UNITED STATES PATENT AND TRADEMARK OFFICE

APPLICATION NO.	FILING DATE	FIRST NAMED INVENTOR	ATTORNEY DOCKET NO.	CONFIRMATION NO.
10/740,255	12/18/2003	Michael John Rutter	CHM-019	1904
38155	7590	10/04/2004	EXAMINER	
HASSE GUTTAG & NESBITT LLC 7550 CENTRAL PARK BLVD., MASON, OH 45040			MITCHELL, TEENA KAY	
			ART UNIT	PAPER NUMBER
			3743

Office Action Summary

DETAILED ACTION

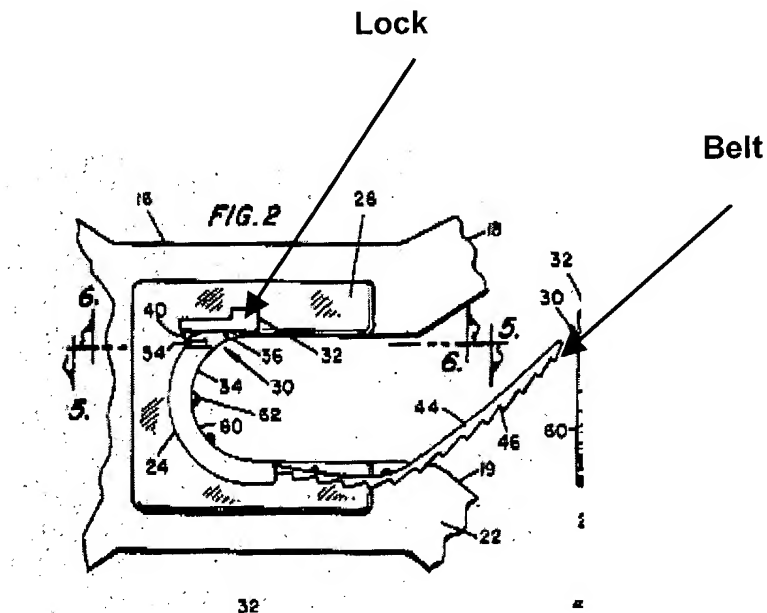
With respect to claim 8, Beran discloses wherein the strip comprises a lock at one end (32) and a belt at the other end (see illustration of Fig. 2 below).
